**RE: Subgrade Inspection for Lot # 19 Woodside Ridge – 2045 NW Ashurst Dr
Lee's Summit, MO 64081 – Permit # PRRES20204752**

On January 22, 2021, a special inspection was performed by Residential Engineering Services, LLC (R.E.S.) at the above referenced property. The purpose of this inspection was to determine structural adequacy of the existing soil for construction of concrete foundation.

SPREAD FOOTING
DETAIL
N.T.S.

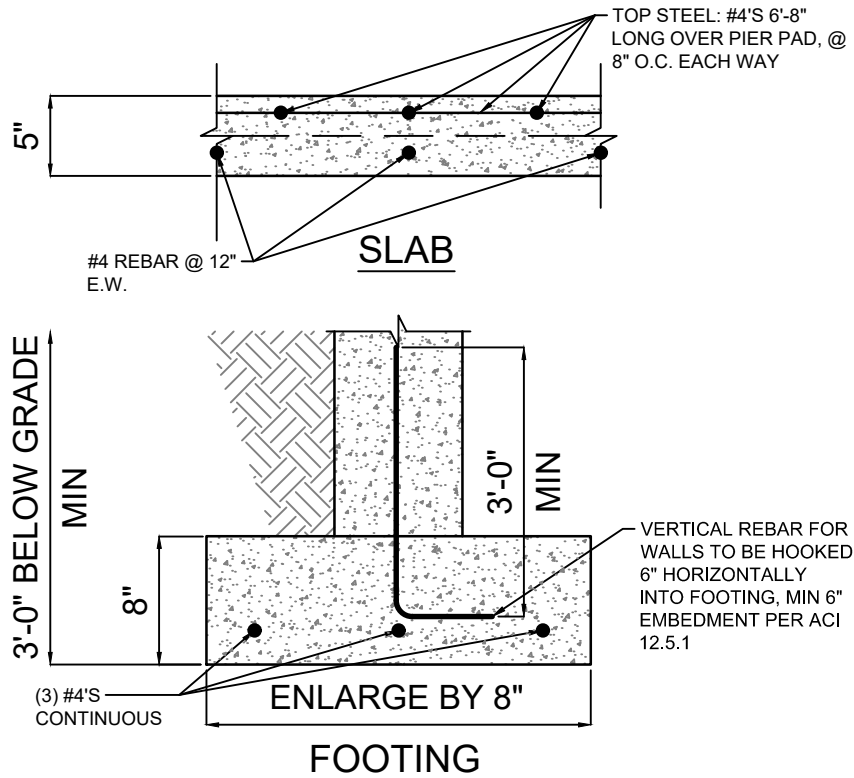
- The soils observed at footing elevation were silty clay; light-medium brown; median plasticity; moist soils with large loose rocks and isolated areas with minimal small roots exposed.
- Areas in the rear of the lot appear to be un-engineered fill.
- Probes indicated that the soils do not have sufficient bearing capacity for the loads applied by foundation per permit plans.

- RES recommends that the footings on the rear half of the lot be enlarged to 24"x8" with three (3) #4 rebar continuous (see attached specifications)
- Applicable basement and garage pier pads in area of concern shall be enlarged a minimum of 6" each way (i.e existing 30"x30" shall be enlarged to 36"x36", etc.) (see attached specifications)
